DATE: 30 April 2012

FROM: WALLER, TODD & SADLER ARCHITECTS, INC.
1909 CYPRESS AVENUE
VIRGINIA BEACH, VA 23451

RE: **ADDENDUM NO. 2**
TO THE REQUEST FOR PROPOSAL DOCUMENTS FOR:
MUNICIPAL / E911 BUILDING
SUFFOLK, VIRGINIA

SKETCH NUMBER
SKA-2

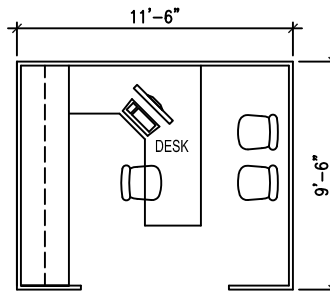
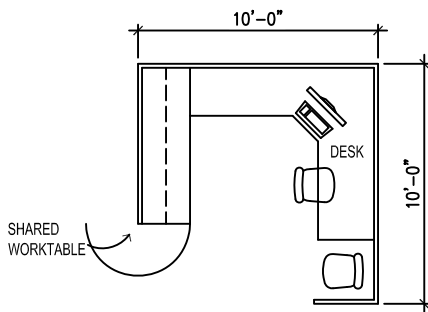
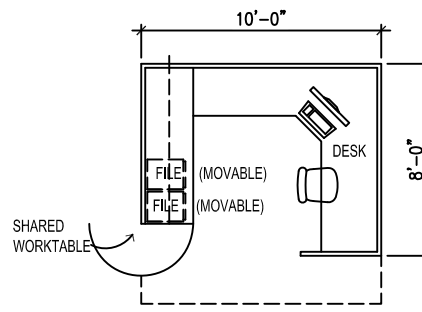
DELETE SKA-2 dated Nov 18, 2011 and **REPLACE** with SKA-2 dated April 20, 2012.
